Committee of Adjustment Meeting
Agenda

Staff Report for Committee of Adjustment

Subject: CN-25-0001, MV-25-0001, MV-25-0002 – Consent and Minor Variance Applications –TAES Architects Inc.

Property Address: 117 Arnold Crescent

VA-001

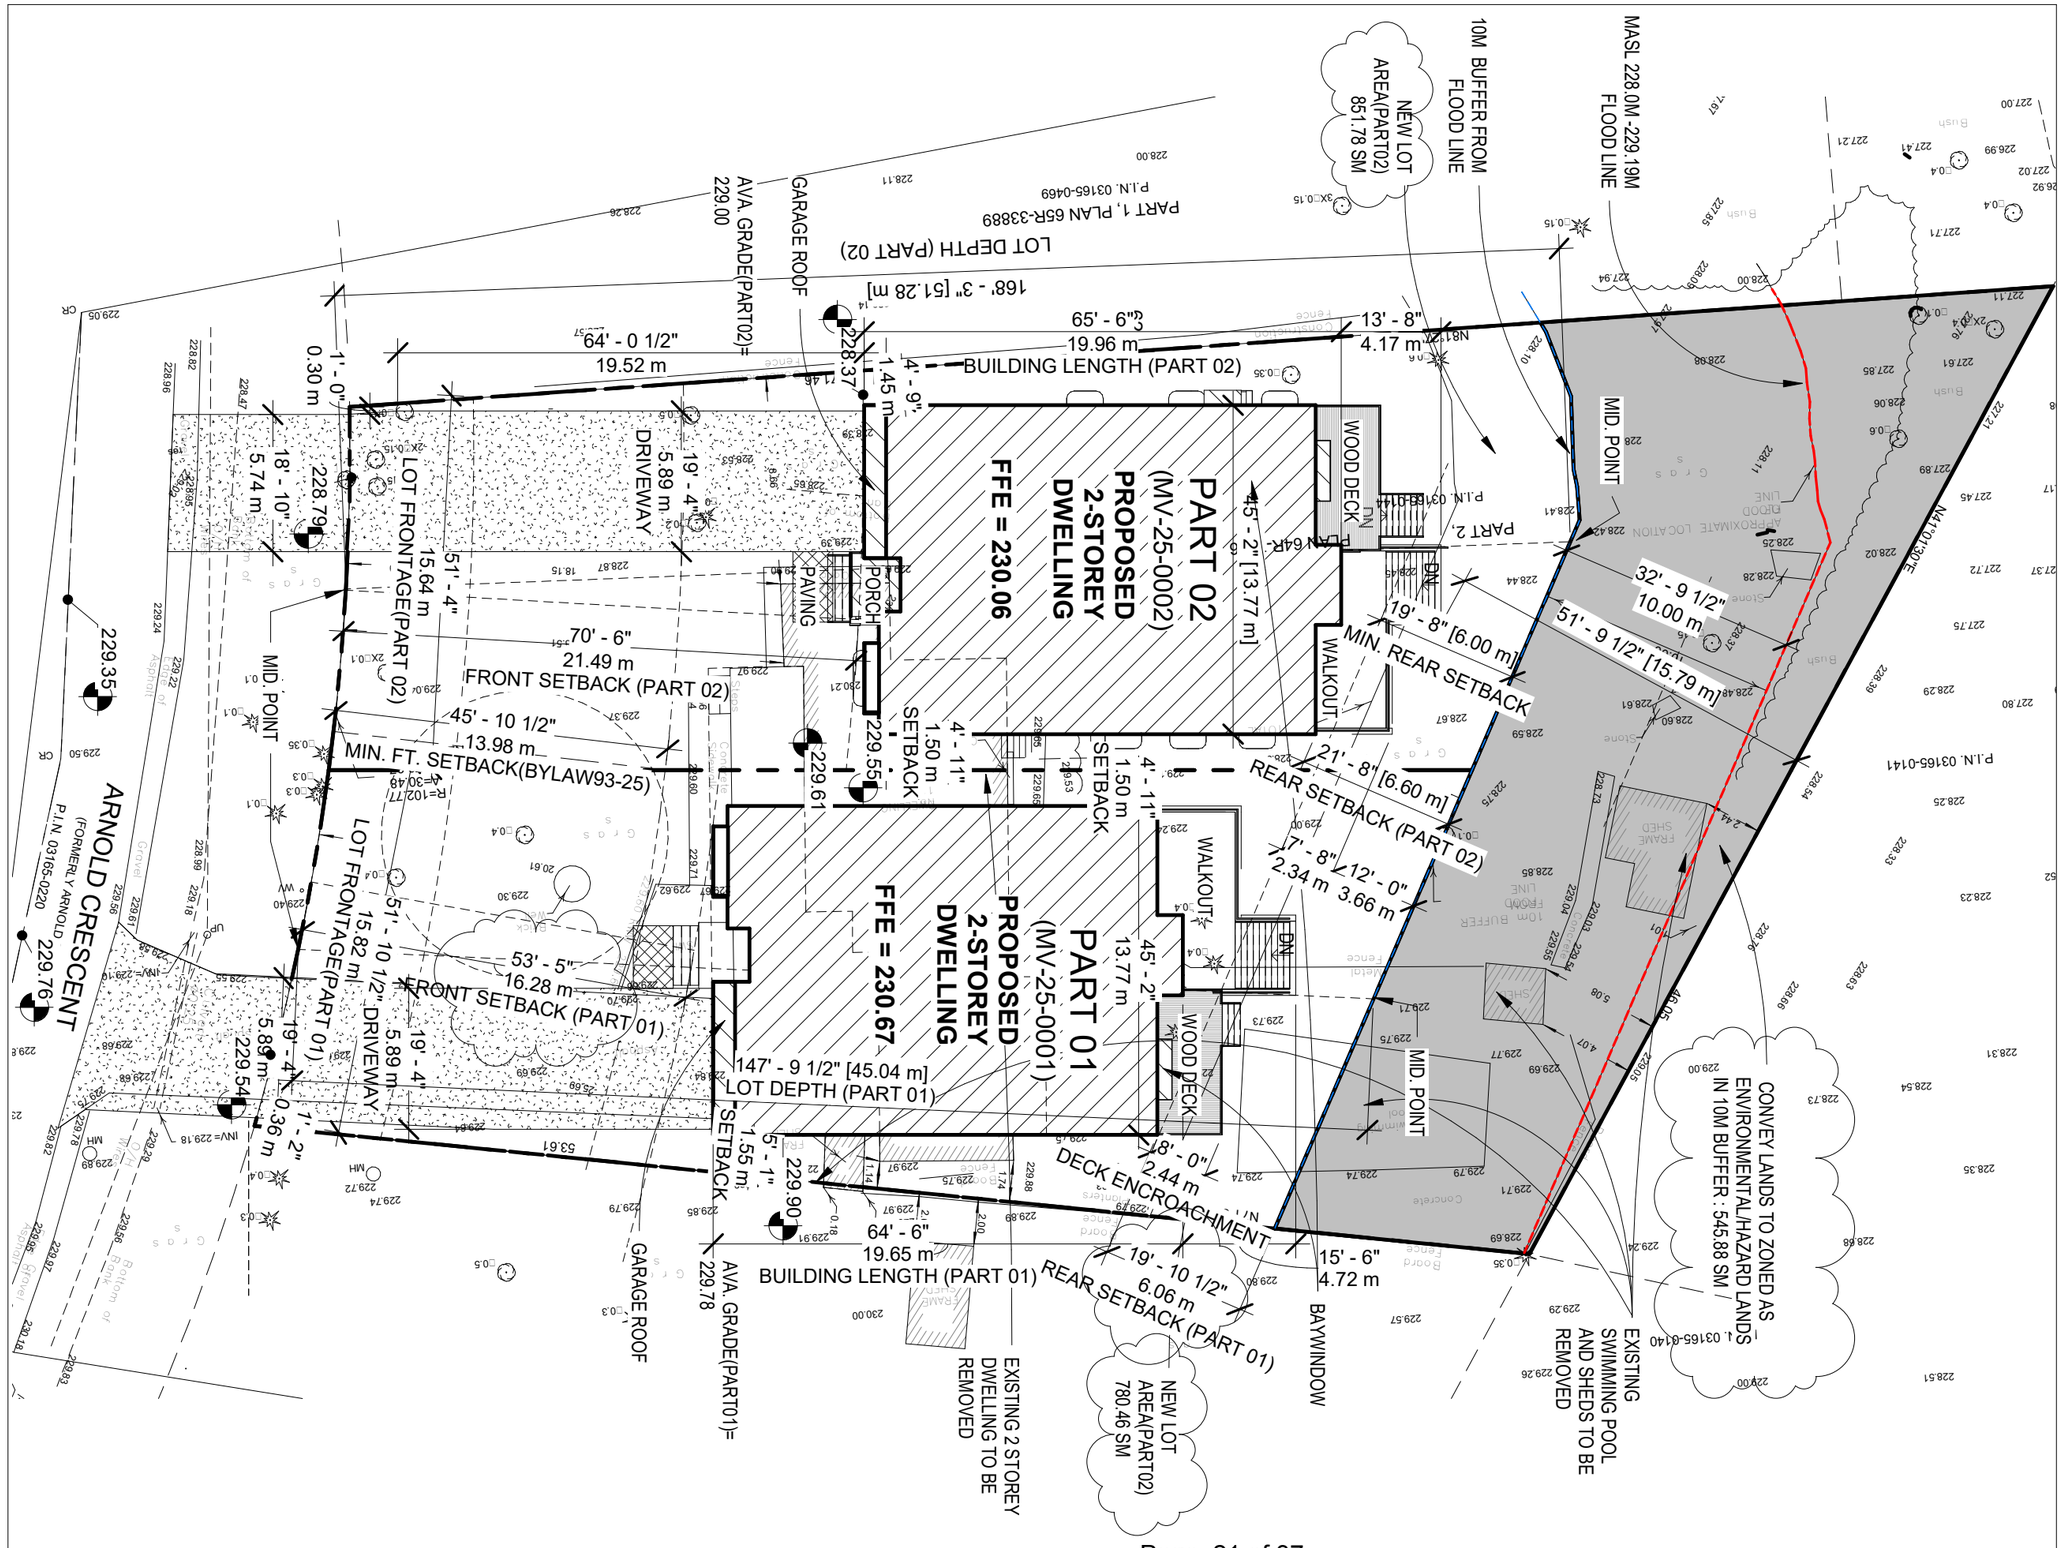
Condition: The owner conveys the lands identified as environmental/hazard lands and associated 10m buffer, as shown on the Site Plan dated July 28, 2026, prepared by TAES Architects Inc.

TRCA staff have worked with the applicant to ensure the floodline is appropriately delineated on the plans. The extent of the floodplain and associated buffer will be contained entirely within one lot (the retained lot) as part of the proposed severance. The proposed severance will therefore not result in the creation of an additional lot within a natural hazard or further fragmentation of the hazard and is consistent with the natural hazard policies of the PPS noted above. As such, TRCA staff have no concerns with the consent application as currently proposed.
